SUBJECT: Forwards draft responses to Reactor Sys Branch questions which will be discussed during 800821 meeting. Responses to Questions 211.201, 211.266, 211.267, 211.268 & 211.269 will be provided on 800821. *See Report*

SUSQUEHANNA STEAM ELECTRIC STATION  
RESPONSES TO REACTOR SYSTEMS BRANCH QUESTIONS  
ER 100450 FILE 841-2  
PLA 518

Attached are PP&L's draft responses to the Reactor Systems Branch questions which will be discussed during the meeting on August 21, 1980.

FIGURE 5.1-3a

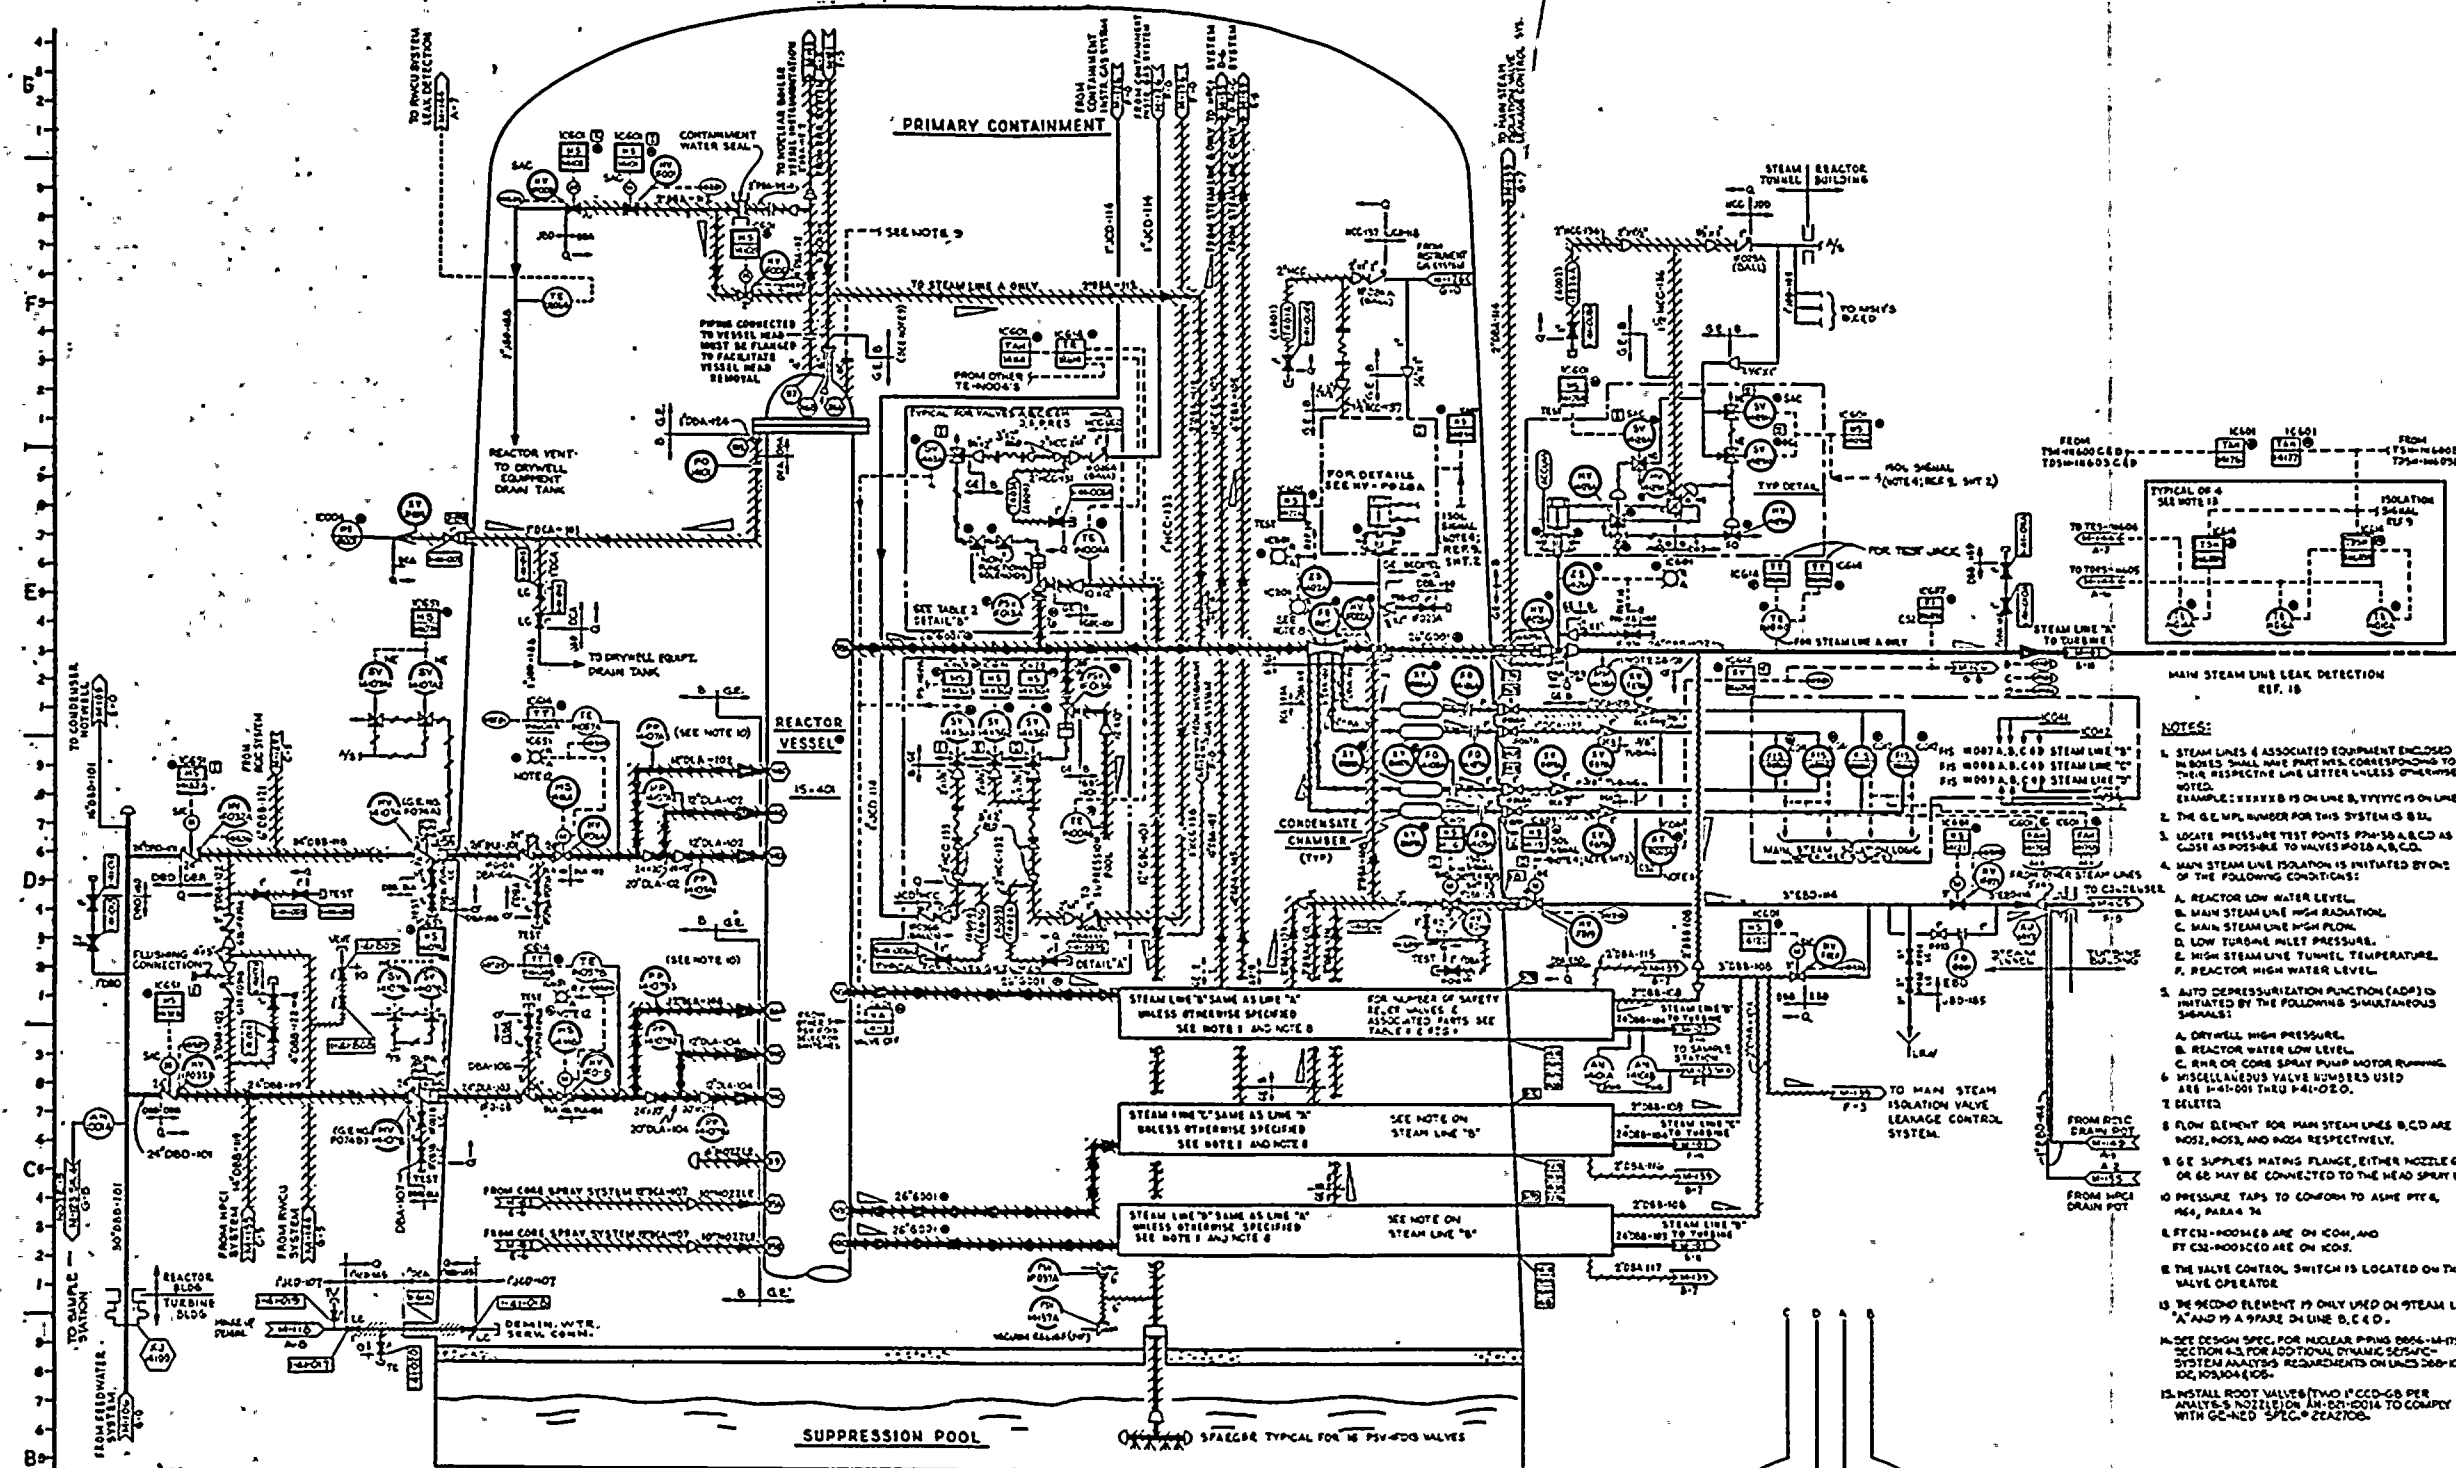
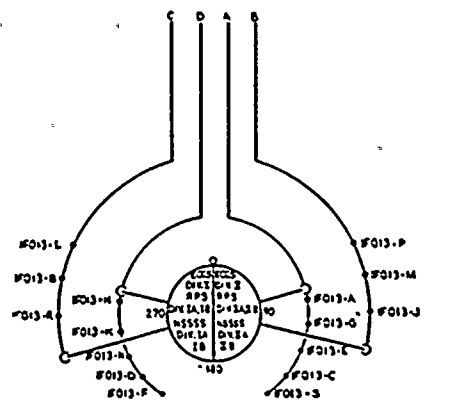
- a) In Table 1 of Figure 5.1-3a (Nuclear Boiler), the relief valve spring set pressure at 1130 psig for safety/relief valves B and E does not agree with a corresponding value of 1146 psig in Table 5.2-2 of the FSAR and in Table 1 of Drawing M-141, Rev. 9. Correct this setpoint discrepancy for safety mode (mechanical) actuation.
- b) For transient analysis, credit has been taken for safety/relief valve actuation in the relief mode. A more conservative approach would be to take credit for safety/relief valve actuation in the safety mode, resulting in higher peak vessel pressures.
  - 1) What effect on MCPR and peak vessel pressure does credit for safety/relief valve actuation in the safety mode have on transients analyzed in Chapter 15?
  - 2) Are all equipment and components required for safety/relief valve actuation in the relief mode safety grade?

- a) The correct, up-to-date, set points for valves B and E are 1146 psig. Table 1 of Figure 5.1-3a has been corrected.
- b) The relief action mode has appropriately been applied to Chapter 15 transient pressurization events. There is no previous or current requirement to assume simultaneous failure of these valves for the transient assessment. No detrimental effect on MCPR would be expected since it is dominated by the scram protection. Any increase in peak pressure is addressed by the bounding, worst ASME code case analysis presented in Chapter 5 and the Vessel Overpressure Protection Report. That analysis shows that completely acceptable overpressure protection is provided even for the worst cases when credit is only taken for accepted ASME valve operation.

FIGURE 15A.6-21

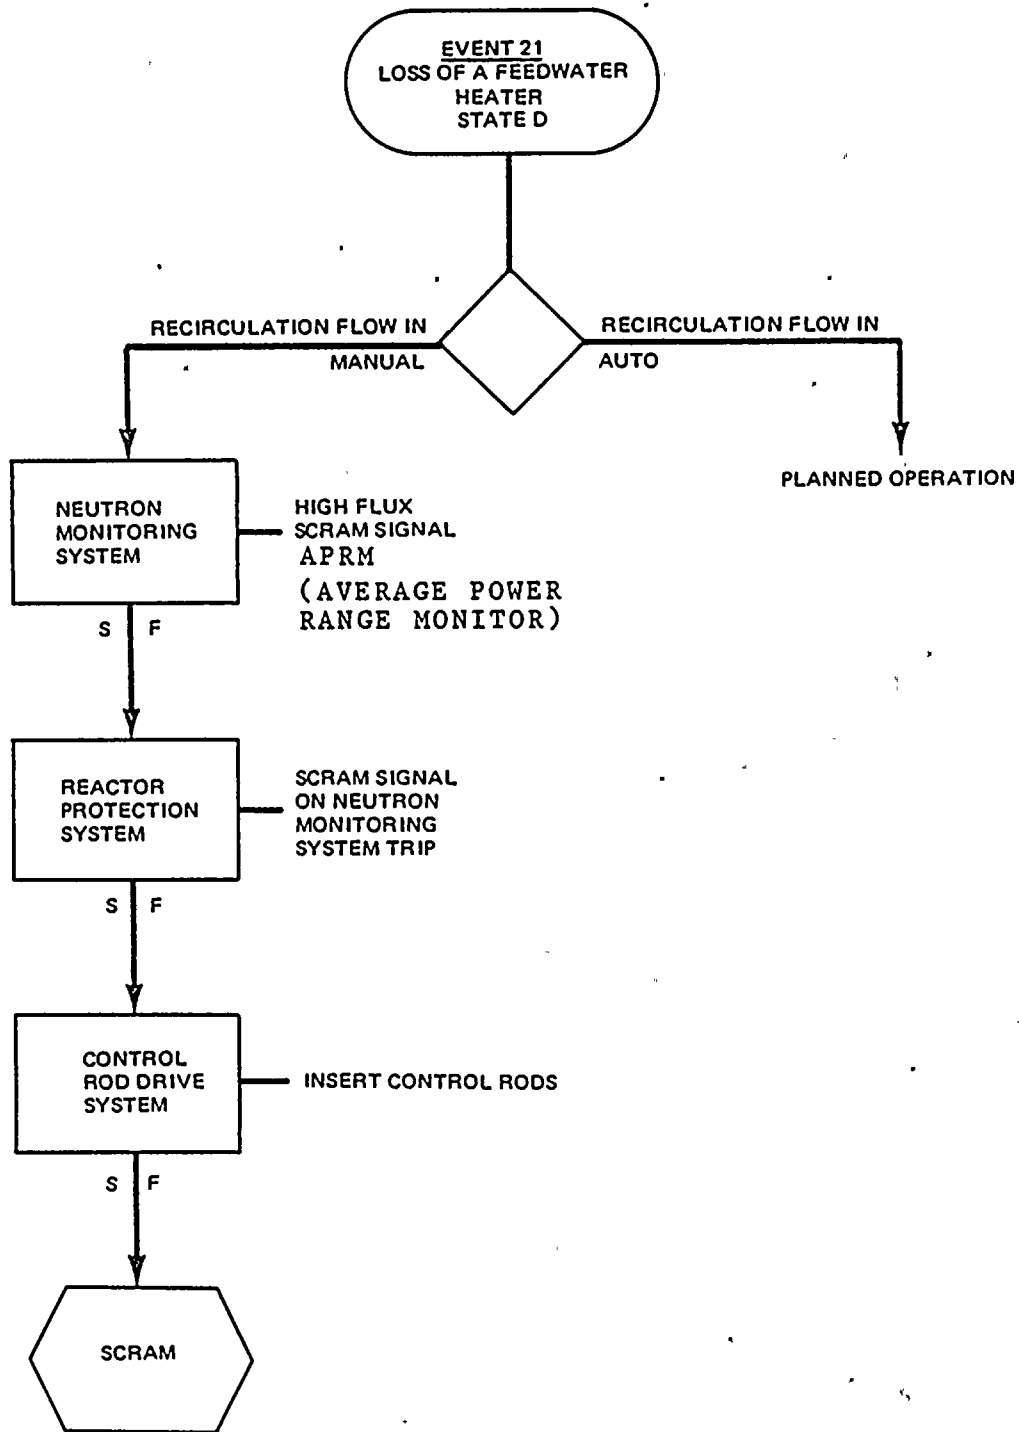
The thermal power monitor (TPM) is not included in the Susquehanna design per response to question 211.118. However, it is indicated as the primary protection system trip for mitigating the consequences of the "loss of feedwater heating" transient in Section 15.1.1.2.2. What was used to scram the reactor in the manual mode? Modify Figure 15A.6-21 and Sections 15.1.1.2.2. and 15.1.1.2.3 accordingly.

The "loss of feedwater heating" transient does not reach nor require scram for either the automatic or manual mode of flow control. Subsections 15.1.1.2.1.1, 15.1.1.2.2, 15.1.1.2.3 and Figure 15A.6-21 have been revised to be consistent with the design of the Susquehanna units.

SUSQUEHANNA STEAM ELECTRIC STATION  
UNITS 1 AND 2  
FINAL SAFETY ANALYSIS REPORT  
PROTECTION SEQUENCES MAIN  
TURBINE TRIP - WITH BYPASS  
FAILURE  
FIGURE 15A.6-31

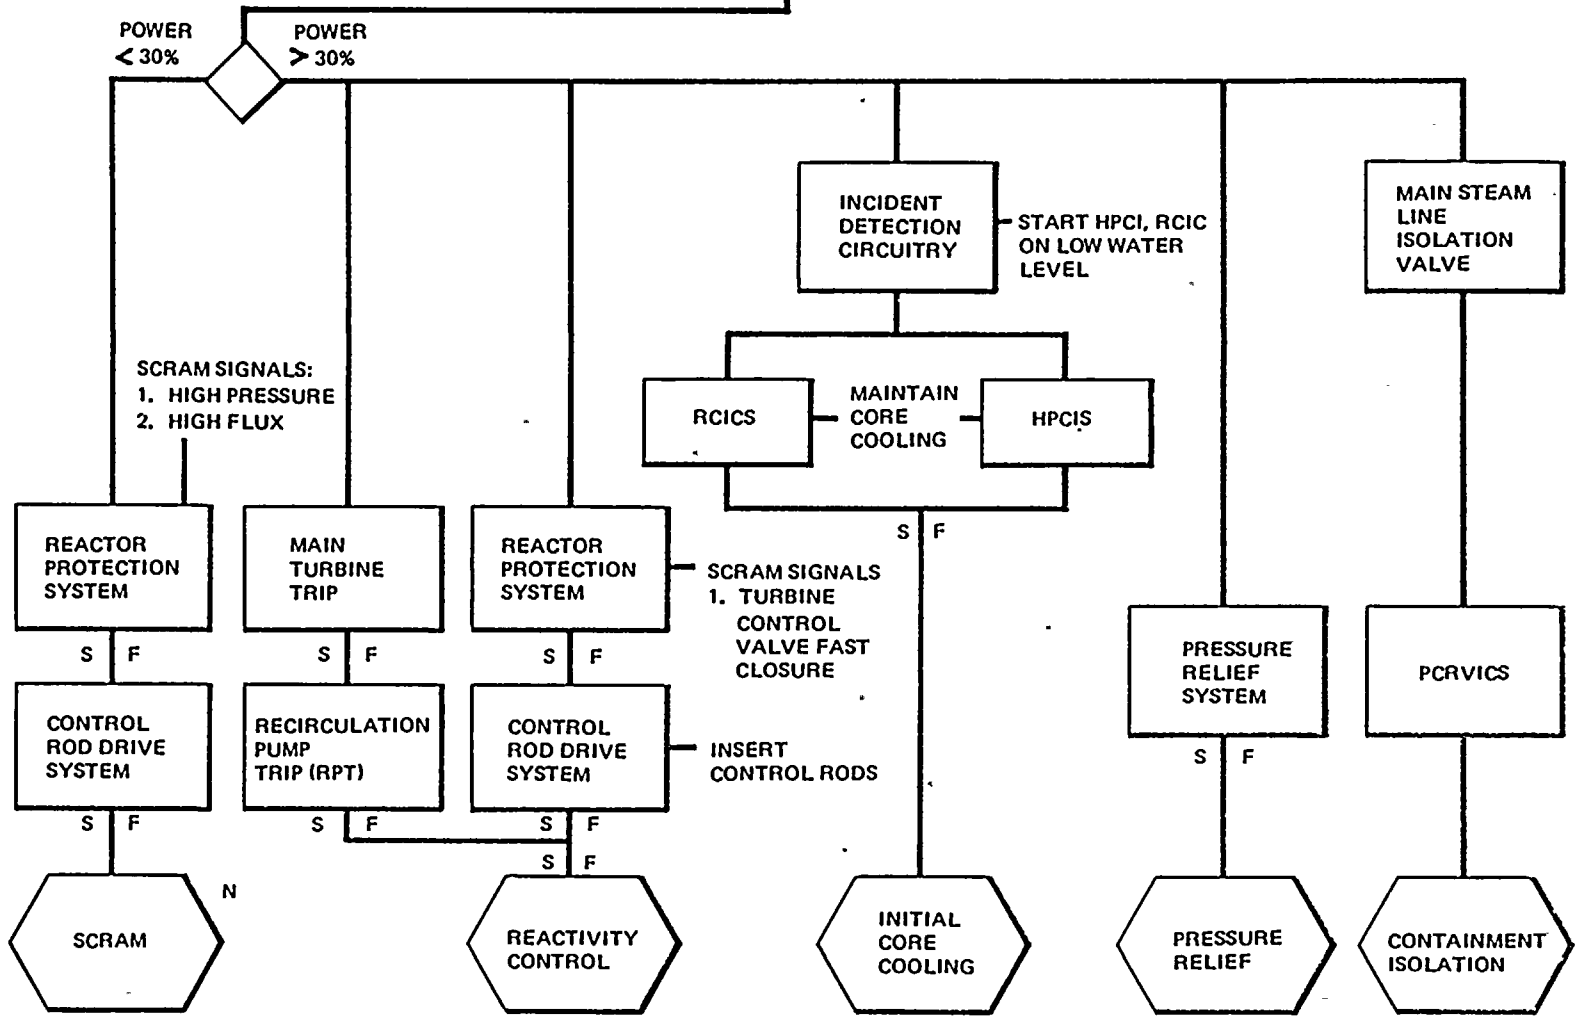
Correct NSOA Figure 15A.6-31, Protection Sequence Main Turbine Trip - With Bypass Failure, by reversing the indicated power levels. This error occurred during revision of this figure per Question 211.110.

Figure 15A.6-31 has been corrected.
